M2PP-121-D-PLNM-0004

Site Specific Management Plan 004 - [sector 410/420]
MacKays to Peka Peka Expressway

01 SEPTEMBER 2014 - CERTIFIED ISSUE - REV C

SITE SPECIFIC MANAGEMENT PLAN - KAPITI MAZENGARB [SSMP 4 - SECTOR 410, 420]

1. AEE ELEVATION - MAZENGARB ROAD BRIDGE EAST ELEVATION - 1:250@A3

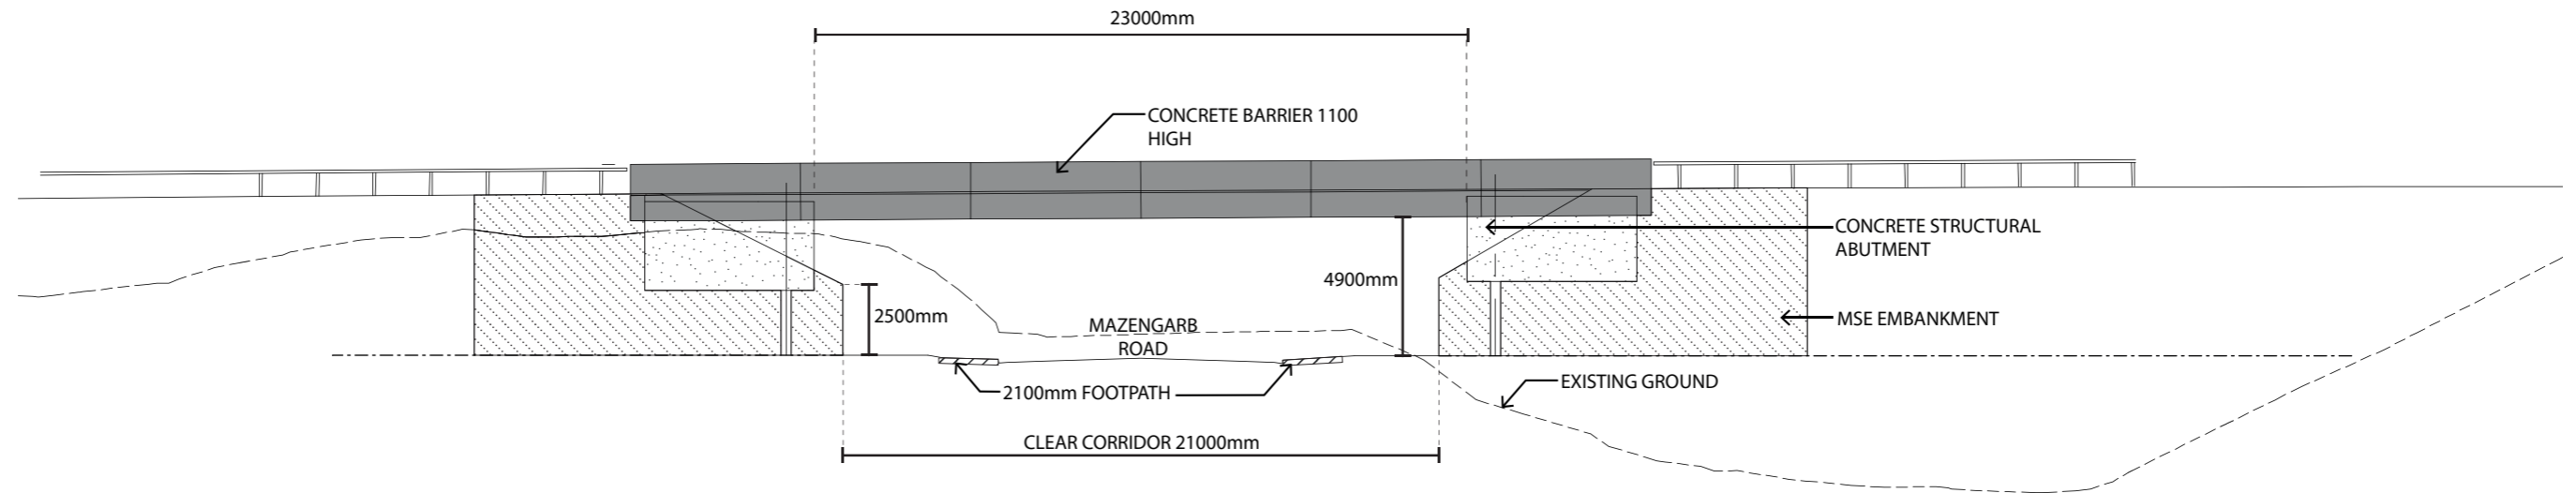
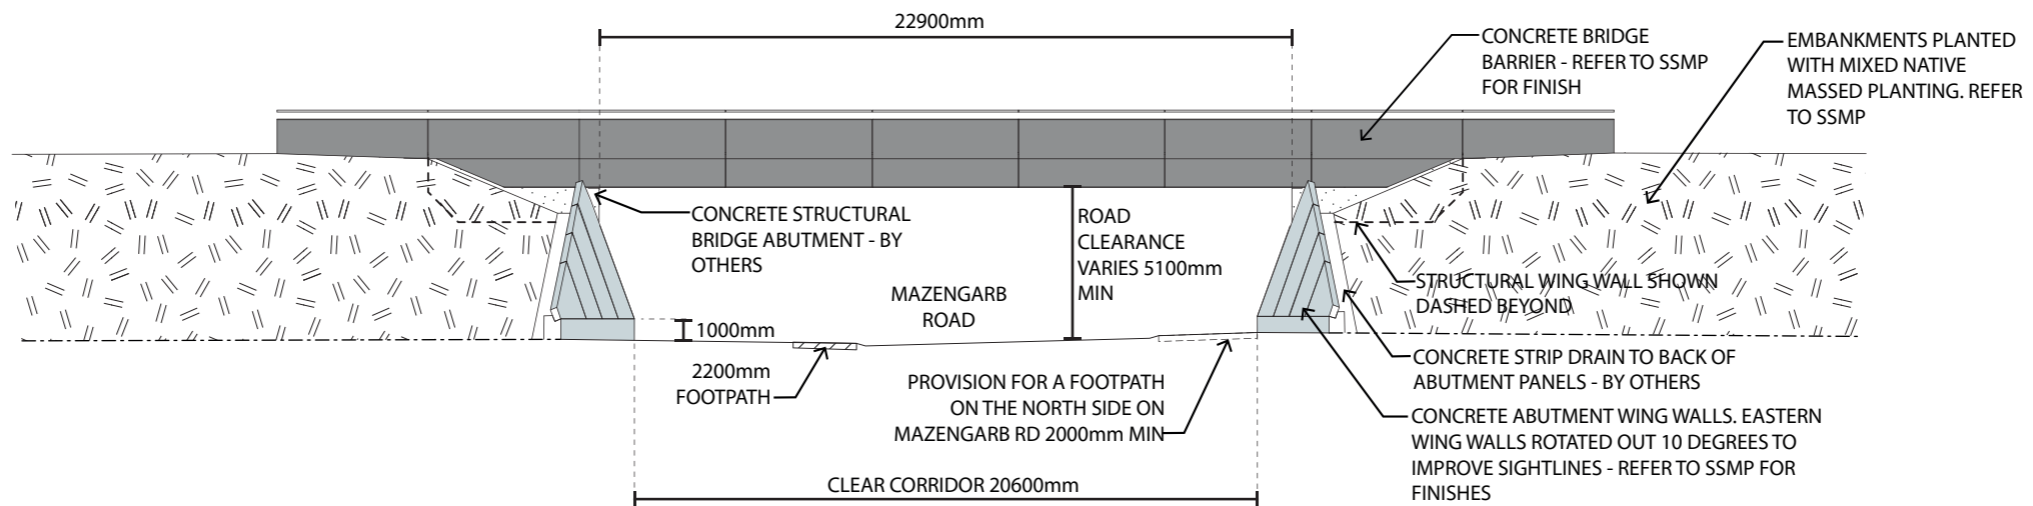
1. Improves constructibility
2. Lack of abutment information in AEE phase. The bridge abutments tie in with and retain the proposed embankments. The abutment wing walls are designed as one long continuous element, they lead pedestrians though and under the bridge connecting one side to the other.
3. Provided for reference only. Refer to SSMP for more detail and finishes
4. No existing footpath to tie in to on the northern side. Space provision for future footpath.

1. AEE SECTIONAL ELEVATION - MAZENGARB ROAD BRIDGE NORTH ABUTMENT - 1:200@A3

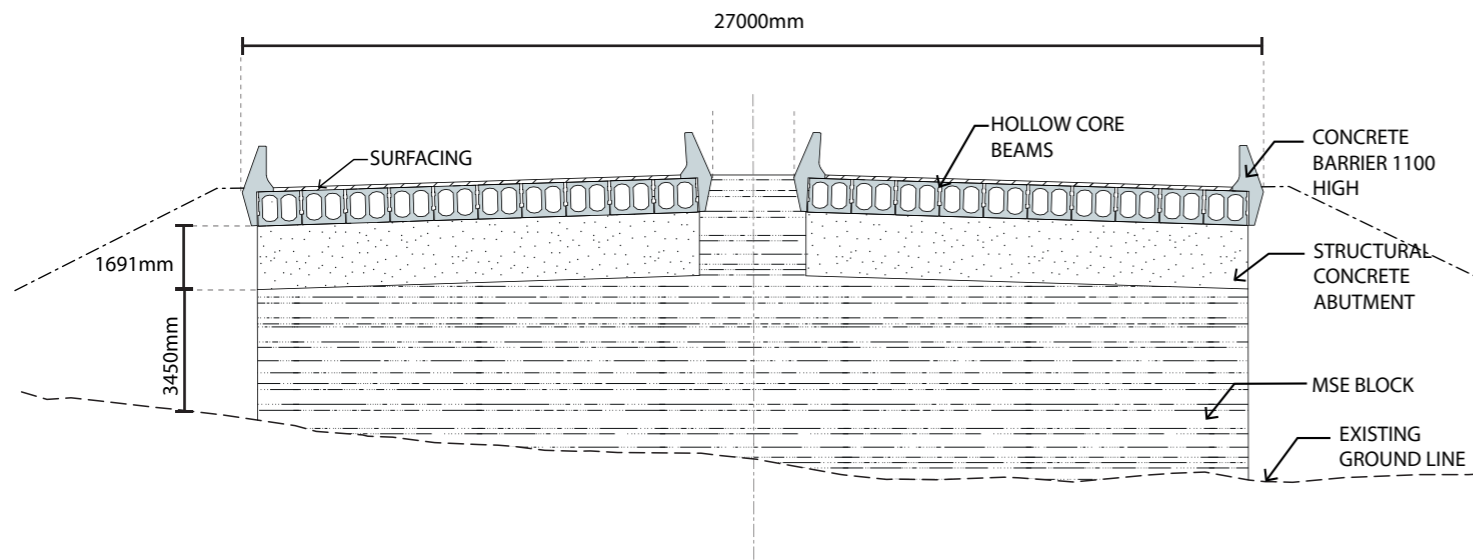
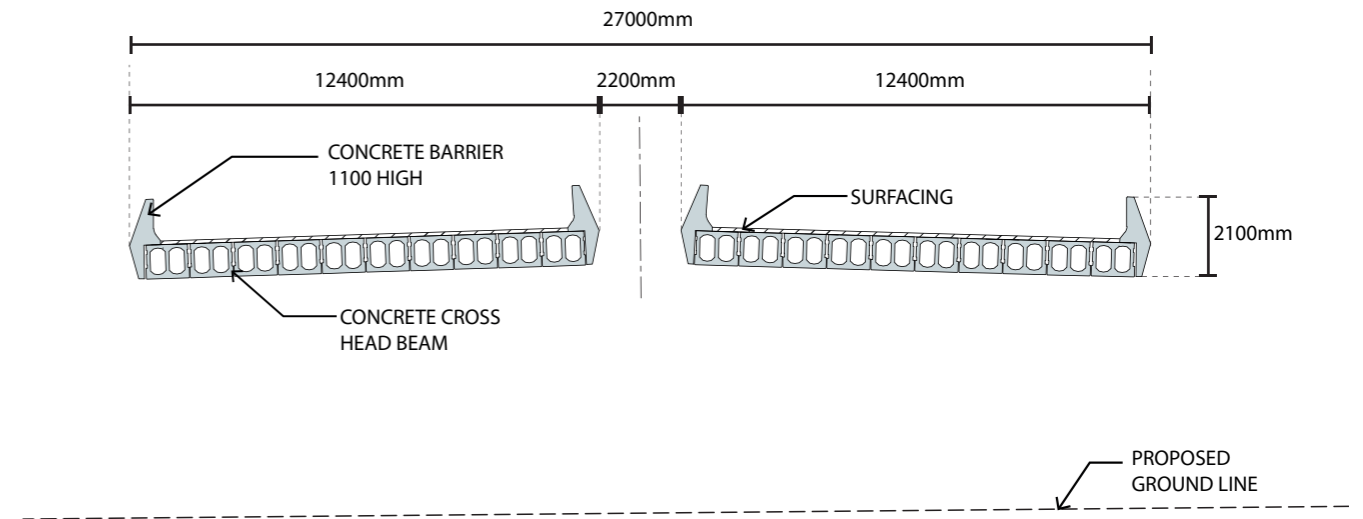
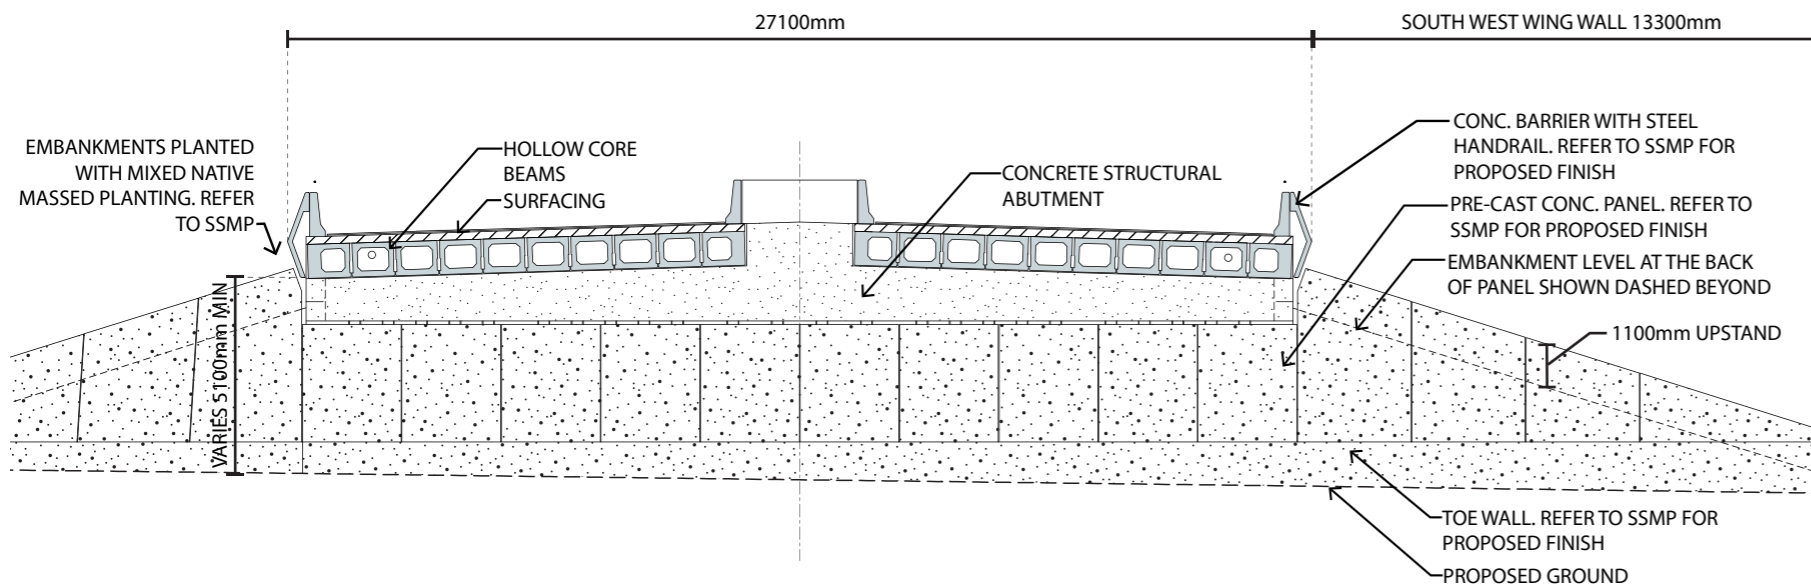
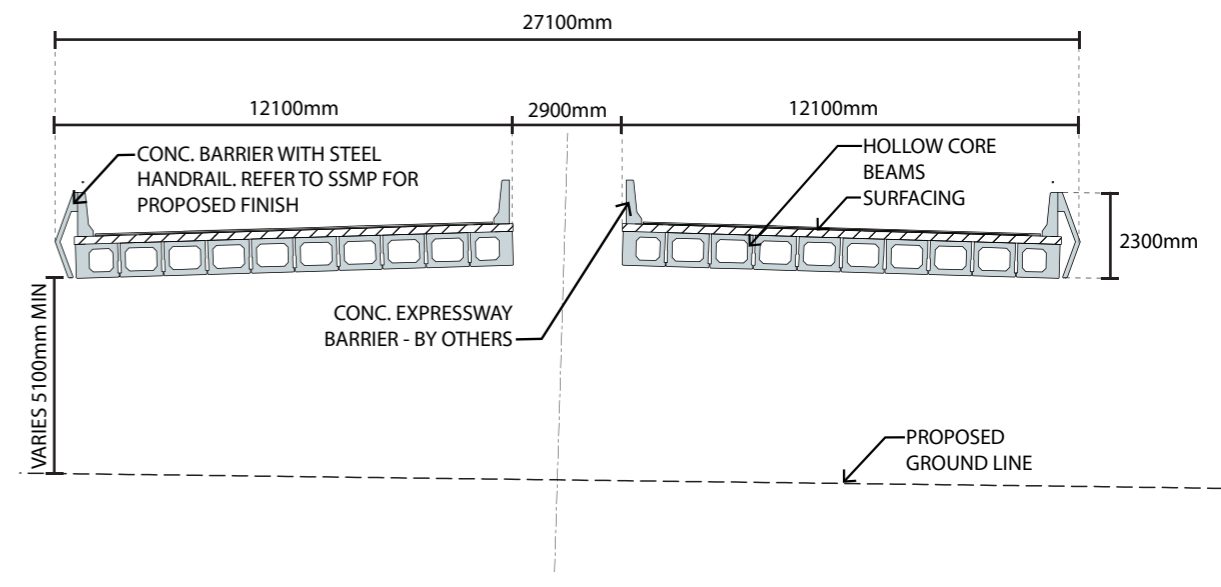
1. Lack of abutment information in AEE phase. The bridge abutments tie in with and retain the proposed embankments. The abutment wing walls are designed as one long continuous element, they lead pedestrians though and under the bridge
2. connecting one side to the other.
No existing footpath to tie in to on the northern side. Space provision for future footpath.

Abutment Elevation 1:100@A3

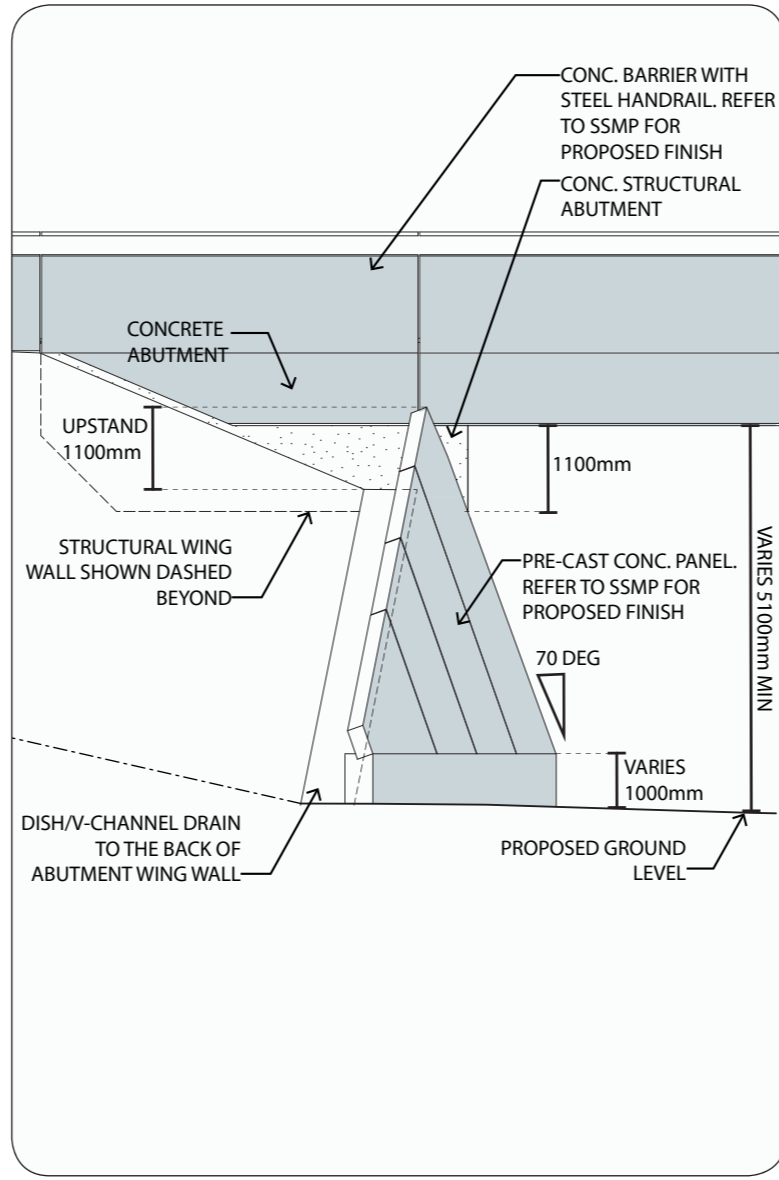
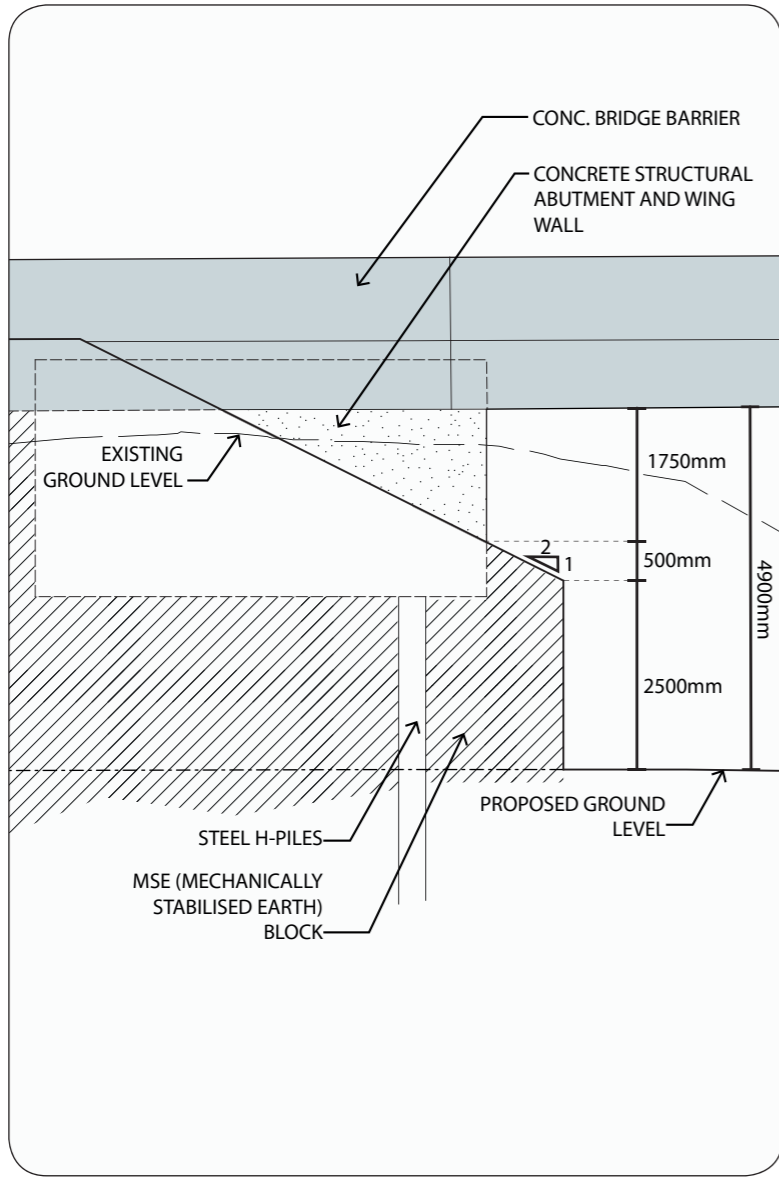
1. More information provided for the bridge abutment
2. Spill through abutment angel reduced.
3. Handrail shown on top of barrier

Cross Head & barrier junction 1:100@A3

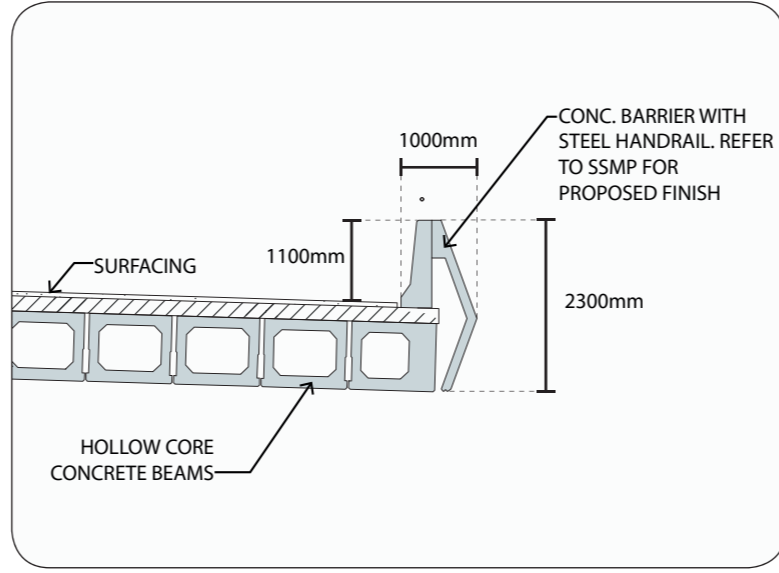
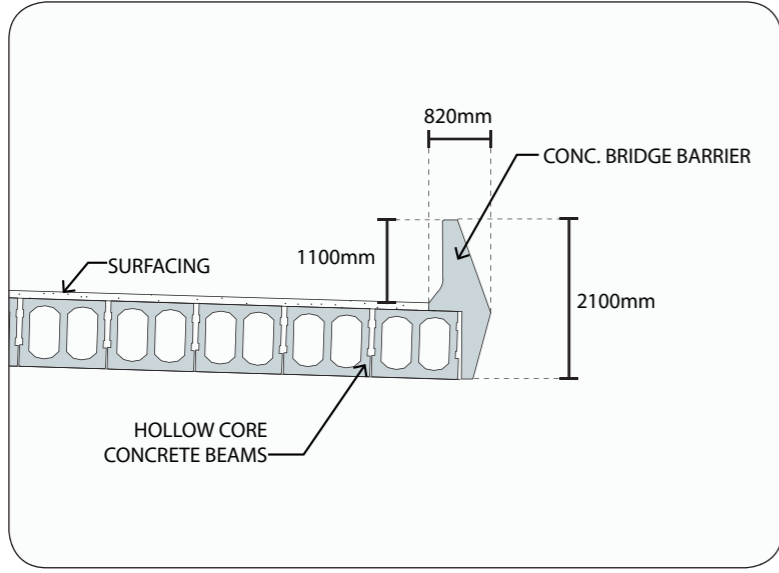
1. Handrail shown on top of barrier
2. Bridge fascia panel height increased
